Amended Acoustic Fence Specification dated March 2023, to replace approved Section 7.1 of the RSK Industrial Noise Assessment, August 2020 (Ref: 297510-RSK-RP-06(04))

Technical Note

Project:	Eastleigh Railway Depot, Eastleigh		
Subject:	Amended Acoustic Fence Specification dated March 2023, to replace approved Section 7.1 of the RSK Industrial Noise Assessment, August 2020 (Ref: 297510-RSK-RP-06(04))		
Prepared:	Federico Gottardo, MIOA		
Date:	7 March 2023		
Reference:	297519-RSK-TN-001	Revision: 0	Approved: Daniel Clare, MIOA

Appendix 2 – Fencing Plan

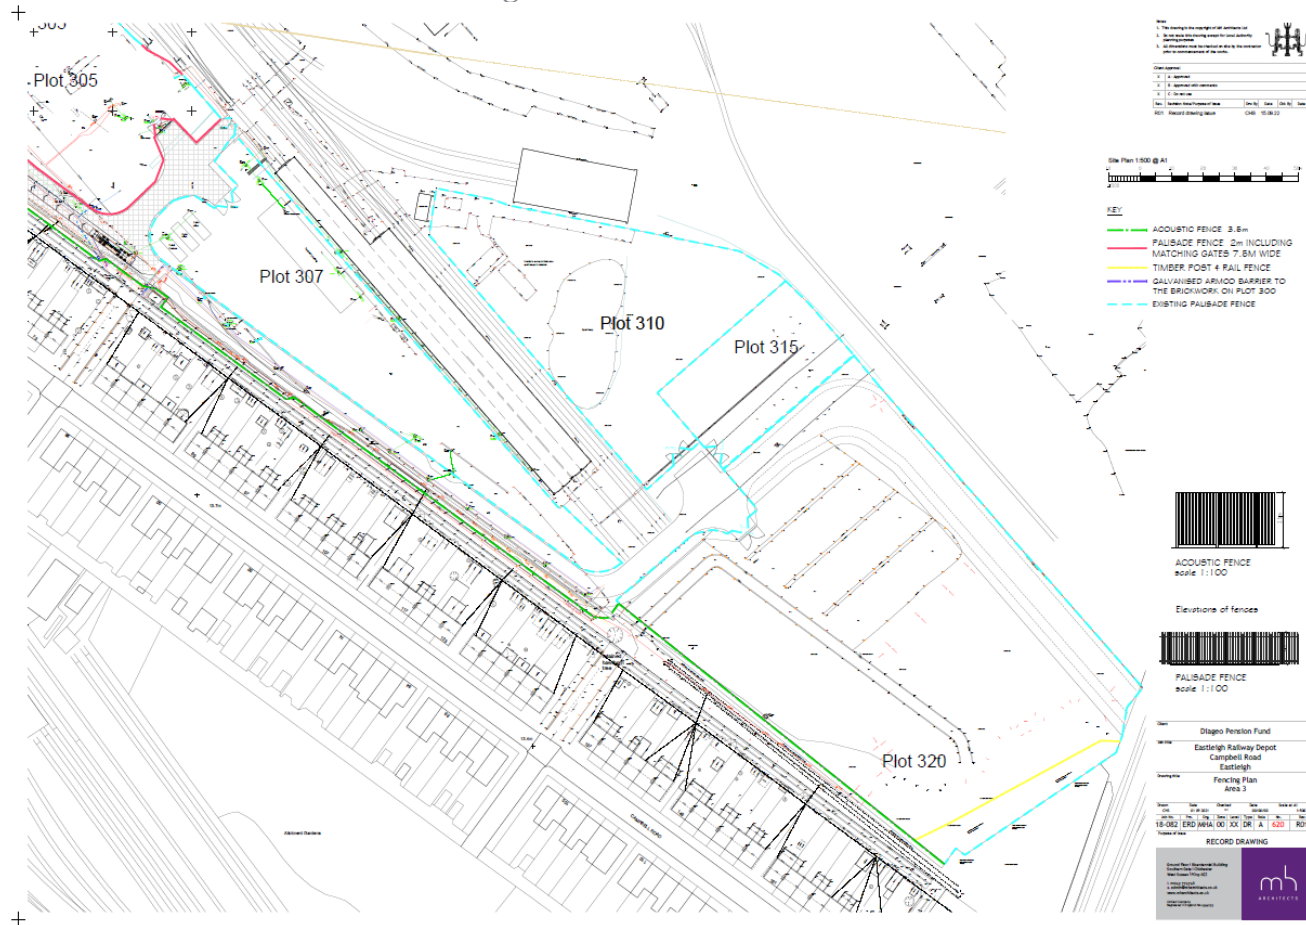
- 2.7 Unlike the prescribed specifications, the installed barrier height is 3.5 metres along its entire length increasing the original specification's height in 1.5 metres for the last section of the barrier running adjacent from 139 to 175 Campbell Road.

- Updated fencing plan including the revised layout and heights (see Appendix 2);
 - Absorption / reflection coefficients representative of a timber fence with no absorbent lining (reflective).
